SUNDRY NOTICES AND REPORTS ON WELLS (DO NOT USE THIS FORM FOR PROPOSALS TO DRILL OR TO DEEPEN OR PLUG BACK TO A DIFFERENT RESERVOIR. USE "APPLICATION FOR PERMIT" (FORM C-101) FOR SUCH PROPOSALS.)		WELL API NO. 30-025-49653

2. Name of Operator Devon Energy Production Co. LP		6. State Oil & Gas Lease No.
3. Address of Operator 333 W. Sheridan Ave OKC, OK 73102		7. Lease Name or Unit Agreement Name PARSELTONGUE 15 10 STATE COM

## Parseltongue 15-10 State Com 29H

Operator: DEVON ENERGY PRODUCTION COMPANY, LP 333 West Sheridan Ave. Oklahoma City, OK 73102	OGRID: 6137
	Action Number: 112735
	Action Type: [C-103] NOI Change of Plans (C-103A)

## Variance Request

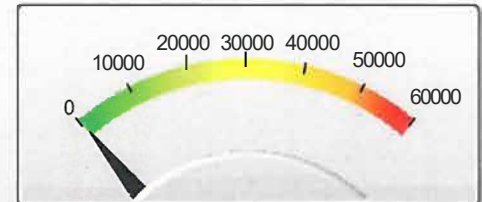
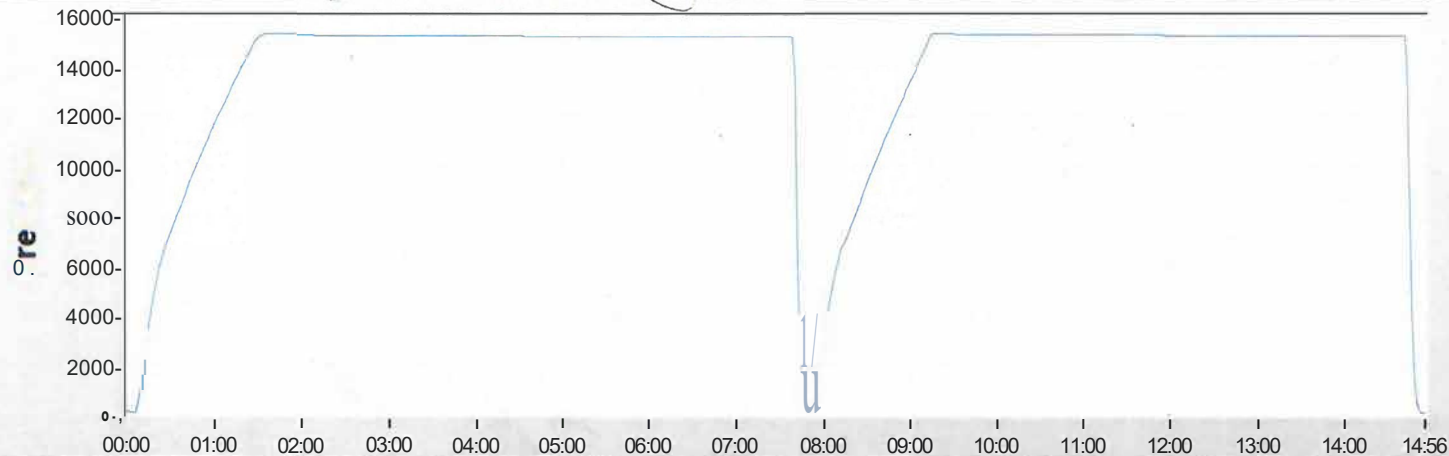
Devon Energy requests to only test BOP connection breaks after drilling out of surface casing and while skidding between wells which conforms to API Standard 53 and industry standards. This test will include the Top Pipe Rams, HCR, Kill Line Check Valve, QDC (quick disconnect to wellhead) and Shell of the 10M BOPE to 5M for 10 minutes. If a break to the flex hose that runs to the choke manifold is required due to repositioning from a skid, the HCR will remain open during the shell test to include that additional break. The variance only pertains to intermediate hole-sections and no deeper than the Bone Springs Formation where 5M BOP tests are required. The initial BOP test will follow OOGO2.III.A.2.i, and subsequent tests following a skid will only test connections that are broken. The annular preventer will be tested to 100% working pressure. This variance will meet or exceed OOGO2.III.A.2.i per the following: Devon Energy will perform a full BOP test per OOGO2.III.A.2.i before drilling out of the intermediate casing string(s) and starting the production hole, before starting any hole section that requires a 10M test, before the expiration of the allotted 14-days for 5M intermediate batch drilling or when the drilling rig is fully mobilized to a new well pad, whichever is sooner. We will utilize a 200' TVD tolerance between intermediate shoes as the cutoff for a full BOP test. The BLM will be contacted 4hrs prior to a BOPE test. The BLM will be notified if and when a well control event is encountered. Break test will be a 14 day interval and not a 30 day full BOPE test interval. If in the event break testing is not utilized, then a full BOPE test would be conducted.

1. Well Control Response:
  1. Primary barrier remains fluid
  2. In the event of an influx due to being underbalanced and after a realized gain or flow, the order of closing BOPE is as follows:
    - a) Annular first
    - b) If annular were to not hold, Upper pipe rams second (which were tested on the skid BOP test)
    - c) If the Upper Pipe Rams were to not hold, Lower Pipe Rams would be third
